AGENDA APPENDIX
Council Meeting
Wednesday 24 August 2016

E.13 LEONGATHA STREETScape MASTER PLAN – FINAL FOR ADOPTION

Appendix 1 Part B – Community Engagement Report

Revitalisation Option A Proposal for Bair St between McCartin & Church Sts in Draft Master Plan

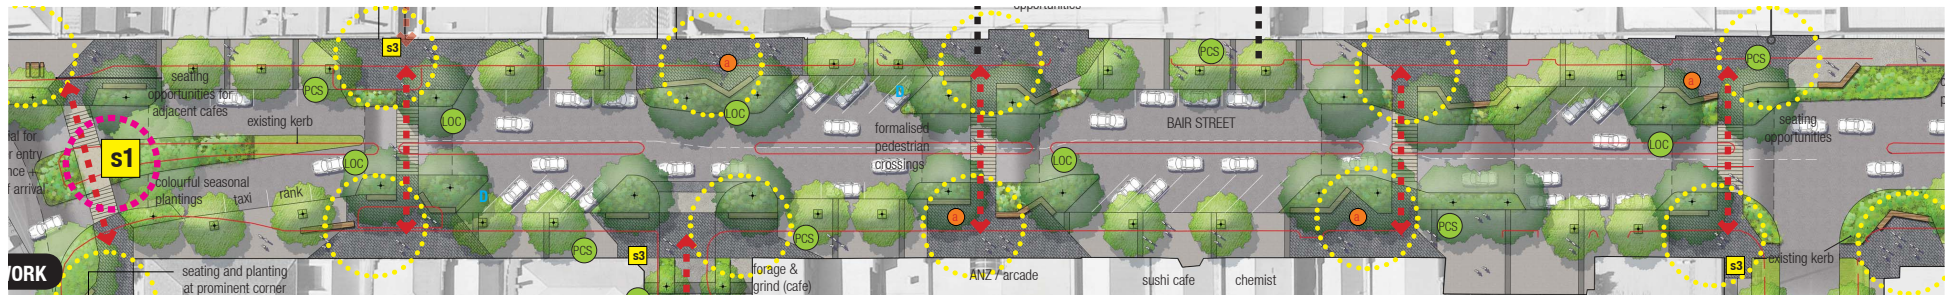
a clear preference for Option B. At the first meeting no-one voted for Option A and most people voted for Option B. At the second meeting a couple of people voted for Option A and everyone else that voted preferred Option B.

Option B "...appears to create a series of interesting spaces along the street, rather than one, long, straight road."

"I believe B will be a more open landscape being easier to see the shop fronts from both sides of the street."

Option B is clearly the preferred option and will form the basis of the final plan with changes in response to other comments received.

Lyon St Proposal in Draft Master Plan

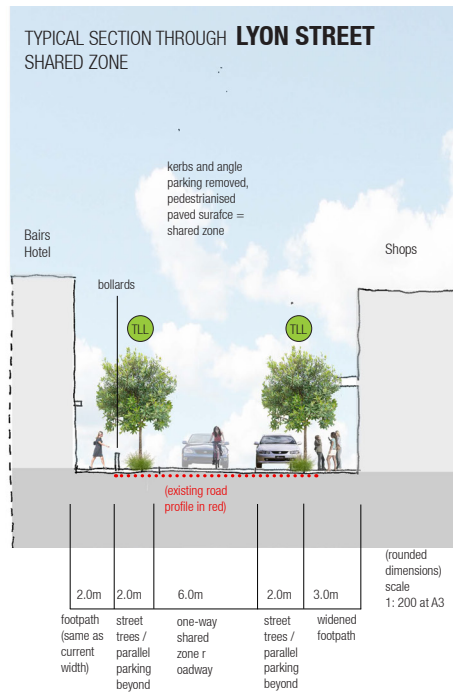
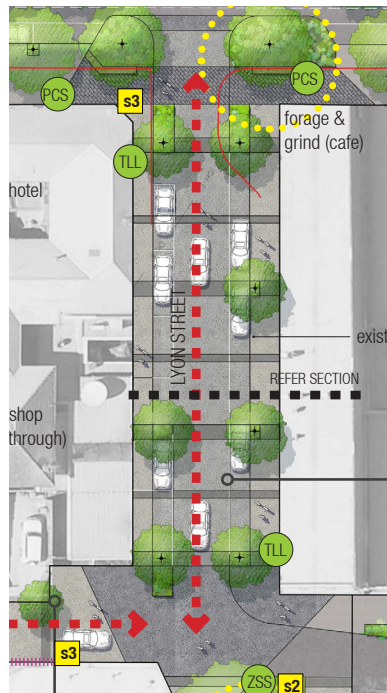
The most common response was relatively neutral (“ok”). Despite this, there were generally more positive responses overall. Businesses and some community members were concerned about the loss of angle parking.

“Looks good. Opportunity for intersection treatment at Gollers Lane, Hyland Place and Lardner Place.”

- Re-organise the parking to retain angle parking and redevelop the accessible car parking space to bring it up to standard and ensure space is retained for planting and seating.

Gollers Ln Proposal in Draft Master Plan

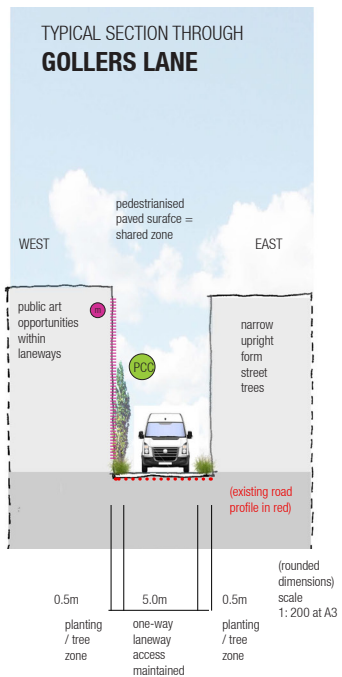
This question received the most negative feedback though the most common responses were positive. There was concern about space for vehicle access to be retained in the laneway, specifically delivery trucks with room to manouvre a vehicle around them. This feedback was mostly from businesses concerned about the proposed vegetation in the laneway. At the same time many people liked the proposed vegetation.

“I am nervous about the plantings on both sides as it means that if a car is trying to go around a truck that is parked, they have to weave a lot. I would prefer any plantings to be on just one side.”

- Remove proposed in-ground trees along the laneway.
- Install removable planting beds on a trial basis.

Hyland Pl Proposal in Draft Master Plan

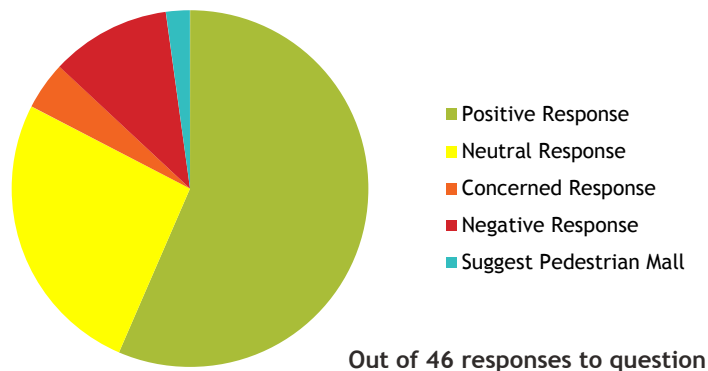
The responses to this proposal were generally positive or neutral. Most supported the proposed planting because it will make the area more appealing, inviting and safer for pedestrians.

Concerns were raised about loading zones, car parking, access and space required for planting.

- Show loading zones on plans.

Lardner Pl Proposal in Draft Master Plan

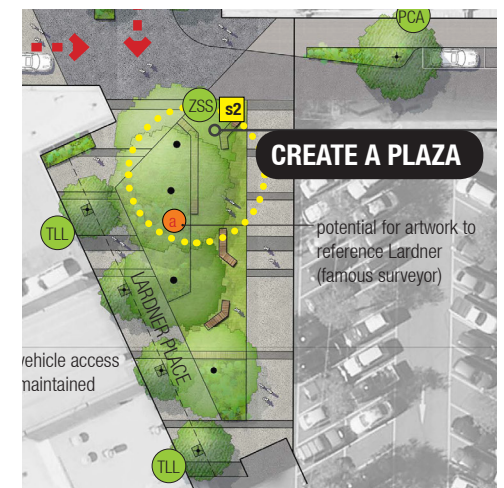
Most responses to the proposal for Lardner Place were positive. The key concerns about this area were from businesses concerned about delivery access being affected by trees planted along the footpath.

- Install a shelter for weather protection.
- Remove proposed planting along the footpath.

Horticultural Park Proposal in Draft Master Plan

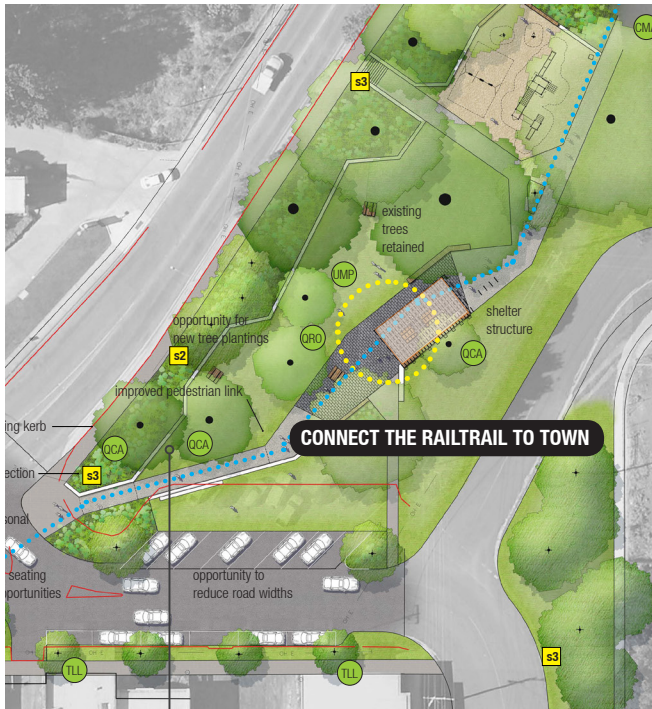
Most responses to the proposal for Lardner Place were positive. There was strong support for improvements to the park and connection with the rail trail. There were also a number of requests for toilets at this end of Bair Street which would cater for shoppers, rail trail users, visitors and park users.

“Needs opening up and better lightning. Currently an area to avoid.”

- Provide greater clarity around the existing and proposed trees (including outside cafe on Young St)
